LOHAN & DONNELLY

Our Ref: 24227

Re: Response to Request for Further Information for Planning Reference
WEBLRD6094/26-S3

Figure 1
Extract from AGL report showing existing made ground over-burden

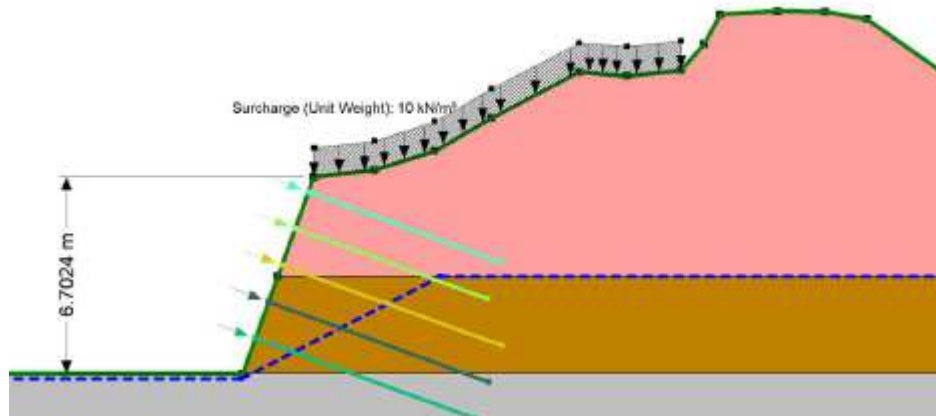
a) The applicant is requested to demonstrate that the proposed development will not impact the railway line and / or safe operations of the railway, confirming no piling or deep foundations will enter the soil anchor zone of influence within the DART+ South West substratum acquisition. The substratum acquisition is required to facilitate the installation and long-term protection of soil anchors along the railway corridor; and hence protect this mass transit route. Any works in proximity to the substratum acquisition shall maintain the required safe clearances to the soil anchors and shall be subject to prior agreement with the DART+ South West team and Iarnród Éireann, including compliance with Iarnród Éireann third-party approval procedures.

In order to develop this site, a significant overburden of made ground must be removed from the site in order to bring the site back to a consistent level at natural ground level. In doing so we are

removing loading from the proposed soil anchors. This is demonstrated in Figures 1 & 2 below which are extracts from AGL report. The AGL report clearly shows us that the factor of safety on the soil nails increases post development when comparing the same soil anchors to predevelopment. Therefore, the proposed development is improving the on-site situation for the soil anchors.
